PIGEON R. BR.

Re: Additional Fdn. Investigation
International Bridge-Pigeon
River Hwy. #61, N.P. 142-60.

Re: Pigeon River Bridge,
Hwy. 61 - Line 'B'
Stuart Location
Thunder Bay District
W.P. 142-60 - Dist. 19.

The detailed foundation report prepared by Dominion Soil Investigation, Ltd., has been reviewed by the Foundation Section. Comments arising from the review of this report, are as follows:-

PROFILE A-A

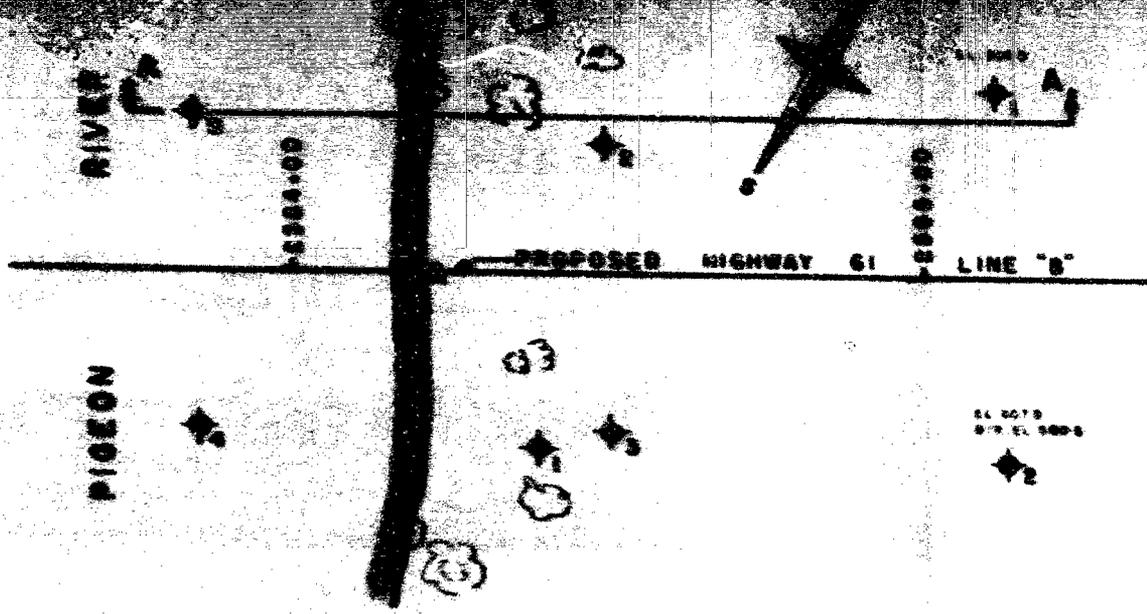
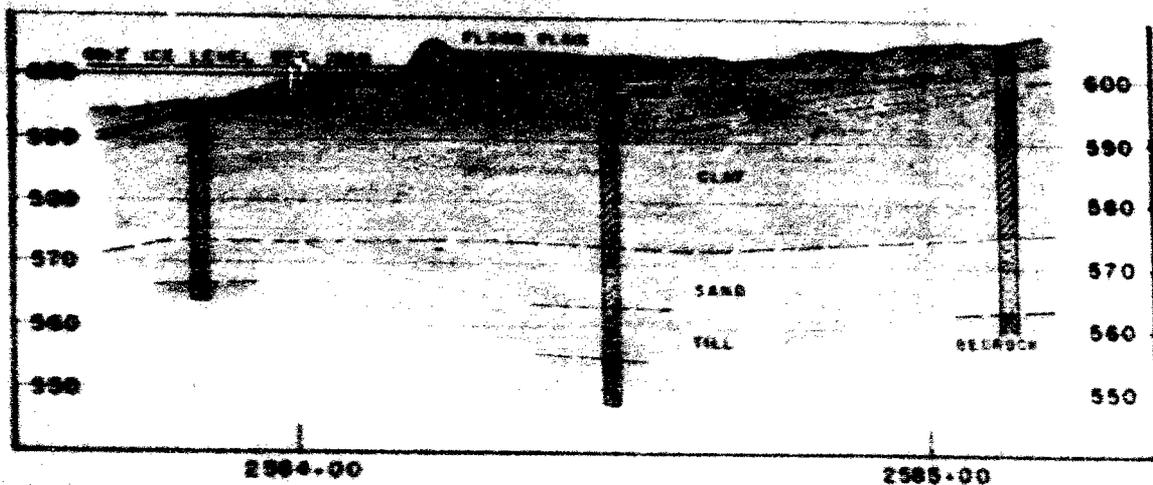
In order to provide information on the stratification and properties of the soil at the new abutment location, two additional boreholes were put down by this Section. The locations of these borings are shown on the attached drawing. The extended subsoil profile A-A is also shown on this drawing.

A surface layer of very loose and soft material of only about 2 feet depth was found in both boreholes. Underlying this material is sand and sandy clay which with depth becomes clay of intermediate plasticity. Below this layer, a layer of sand overlying bedrock was found. The stratification in both boreholes is similar but the bedrock elevations are different. Bedrock was encountered in BH 1 at elev. 982.0 while in BH 2 it was already at elev. 980.5. This indicates a sloping of the bedrock in the northern direction.

The proposed excavation of the soft surface layer as indicated on the above mentioned drawing No. D-4648-2 should be carried out. The properties of the underlying strata are such that there is no stability problem for the limited approach fill. The settlements will be small and therefore tolerable.
